### TCN - 01

Ref: PSER:SCT:KLN-C1865:TCN-01

Sub	Tender Change Notice (TCN) - 01.	
Job	PACKAGE-12: Construction of 275 M tall twin flue GRP liner RCC chimney and other incidentals complete as detailed in the specification including raft foundation at 2x660 MW Maitree STPP, Rampal, Bangladesh.	
Ref	1.0	Tender no PSER:SCT:KLN-C1865:17.
	2.0	BHEL's NIT, vide reference no PSER:SCT-KLN-C1865:6285, Date: 21-11-2017.
	3.0	Other References, if any.

**SPECIFICATION  
FOR  
DUCT(GRP) AT FGD OUTLET**

TITLE : **LOADING OF FLUE GAS DUCT AFTER FGD**

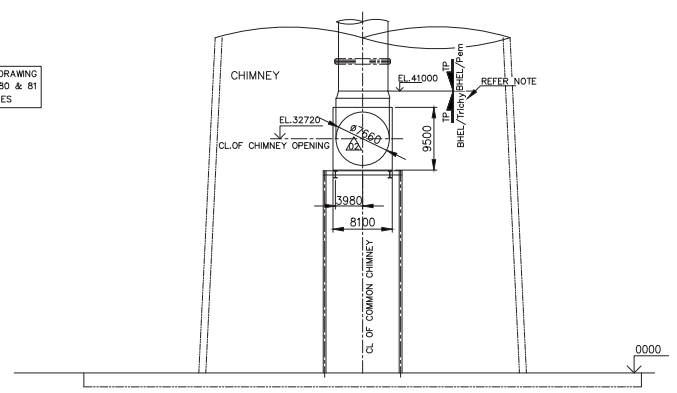
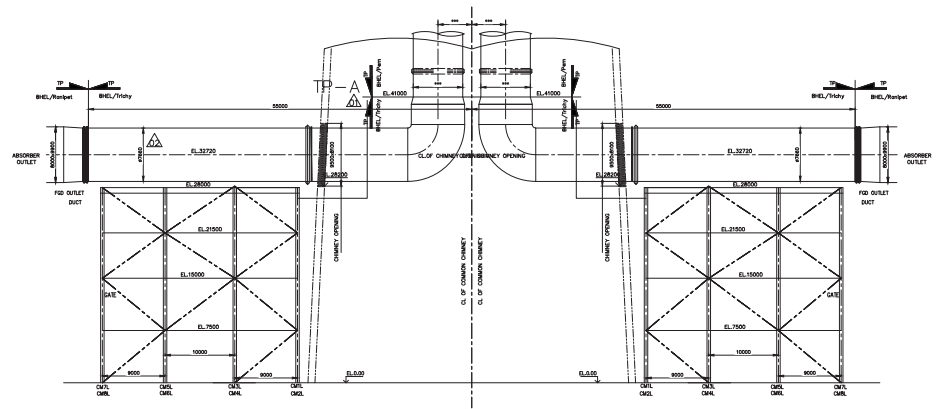
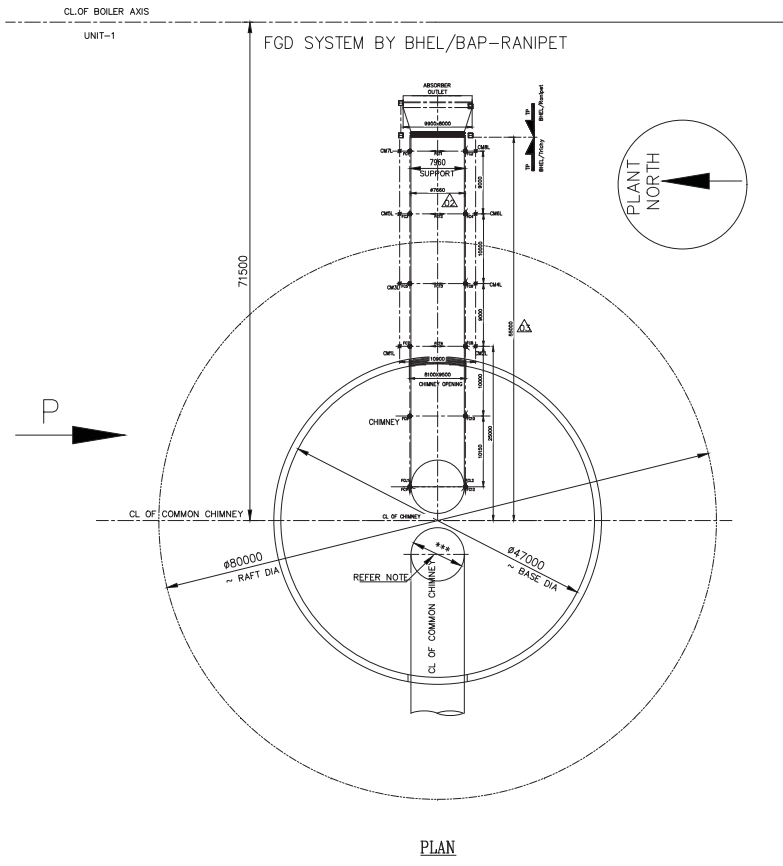
REV 03	DATE 20.11.2017	ALTERED : HARIKRISHNAN CHD & APPD : MUTHUKUMAR	REV 02	DATE 12.10.2017	ALTERED : HARIKRISHNAN CHD & APPD : MUTHUKUMAR	REV 01	DATE 22.08.2017	ALTERED : HARIKRISHNAN CHD & APPD : MUTHUKUMAR
ZONE	GRP DUCT LOAD TABLE CORRECTED DUE TO LAYOUT CHANGE.		ZONE	GRP DUCT SIZING REVISED.		ZONE	TERMINAL POINT LOCATION CHANGED FROM EL.39000 TO EL.41000 AT CHIMNEY INLET.

- TP-A refers to terminal point between duct inside chimney and chimney flue as shown above in view-P.
- TP-B refers to terminal point between FGD outlet and duct from FGD to chimney as shown above in view-P.
- The duct portion between TP-A and TP-B is supposed to release by BHEL-Trichy. Since the material of duct between TP-A and TP-B is GRP, we request BHEL-PEM to supply the duct between TP-A and TP-B along with supports as shown above in view-P.
- Following shows the loading table considering duct material as steel. GRP duct vendor to provide loading table to BHEL/Trichy for providing structural beam to support GRP duct (Duct supports are in the scope of GRP vendor) duct loads are provided in the Load table.
- Duct supports shown are tentative and are to be confirmed by GRP duct vendor to ensure the availability of duct support beam.
